Supplemental Filing

Wuskwatim Generation and Transmission Projects

Responses to Technical Advisory Committee

August 8, 2003

DFO S-39.
Figure 1

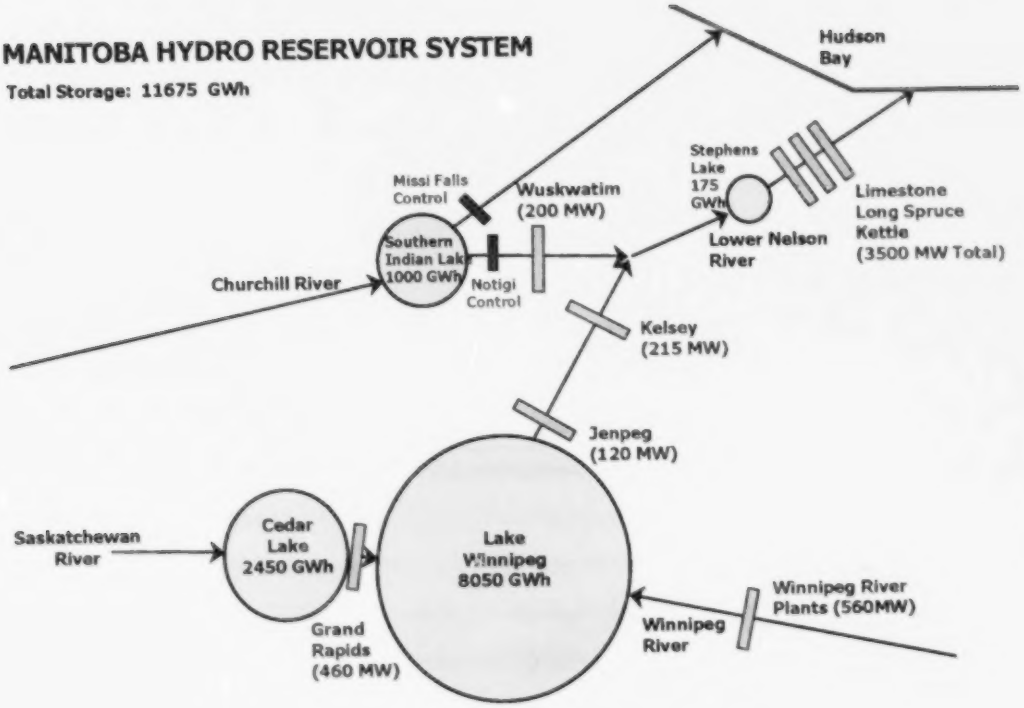
Comm. No.	Page (DFO no. or Para.)	Nature of Comments			Response from Manitoba Hydro and Nisichawayasihk Cree Nation (NCN)
		EIS Section	Issue	Summary of Comments	
DFO-S-39	10 (54)	Vol. 3	Need for information on fish habitat impacts, monitoring and reporting re changes to operation of the northern hydroelectric system	"Information provided at the "Needs and Alternatives" Technical Workshop (July 09, 2003) indicated that the "Wuskwatim Project would not change CRD operation and will not change flow patterns except for daily flow shaping in local area of Wuskwatim" but that "with the Project there may be a small effect on Lake Winnipeg Regulation" depending on the nature of the use of energy generated by the Project. a) Please indicate if the changes in system operation (under maximum potential change circumstances) could potentially impact fish habitat. b) Indicate how monitoring and reporting on system changes that could potentially affect fish habitat will be undertaken and reported."	The response to this question is provided in two parts. Part A is attached as Appendix B-DFO-S-39 and provides a conceptual explanation of the Hydro System operation and the role of the proposed Wuskwatim Generating Station, including possible effects on system operations. Part B follows below and draws on the information provided in the appendix. B) Cross Lake, which is immediately downstream from Jenpeg, is used as an indicator of the effects of LWR operational changes on fish habitat. Part A states that if Wuskwatim energy is used for domestic purposes or for firm export sales "that the summer elevation of Cross Lake is expected to decrease by an average of 0.04 feet with a maximum decrease of 0.11 feet" and that the "average winter elevation is expected to increase by 0.04 feet with a maximum increase of 0.12 feet". It also indicates that "these changes are so small that they will not be perceptible relative to the many other factors that affect outflows from Lake Winnipeg". Effects on fish and fish habitat from water level changes of the above stated magnitude are expected to be neither significant nor measurable with a "well designed sampling program". Over-wintering capacity may be slightly increased in the winter and feeding and rearing habitat may be marginally decreased in the summer but it is expected that neither (even under maximum conditions) would be of sufficient magnitude to measurably affect fish populations either positively or negatively. Effects would be completely masked by other factors such as normal changes in water supply (8 feet), wave up-rush (4 feet), ice staging (0.8 feet), and wind set up (0.5 feet). Part A also indicates that if Wuskwatim energy is used for non-firm export sales "that the summer elevation of Cross Lake is expected to increase by an average of 0.12 feet with a maximum increase of 0.34 feet" and that the "average winter elevation is expected to decrease by 0.08 feet with a maximum decrease of 0.20 feet". with "no perceptible change in elevation in both the upper and lower quartiles". Although the changes are marginally higher than for firm export sales, they remain small and the effects on fish and fish habitat (even under maximum conditions) are expected to be neither significant nor measurable with a "well designed sampling program". Feeding and rearing habitat may be marginally increased in the summer and over-wintering capacity may be slightly reduced in the winter (during average flow periods) but neither would be of sufficient magnitude to measurably affect fish populations either positively or negatively. Manitoba Hydro routinely collects detailed information on water levels and flows throughout its operating system. The information will be made available upon request.

generation does not affect CRD operation. An analysis of the historic elevation patterns on Southern Indian Lake pre and post the Limestone G.S. illustrates that the frequency of the various lake elevations did not change materially after the addition of Limestone (see Figure 3). In a similar manner, Wuskwatim, which is a much smaller plant, will also not have an effect on CRD operation. This is because neither of these projects have an effect on the primary purpose of CRD, which is to augment winter flows.
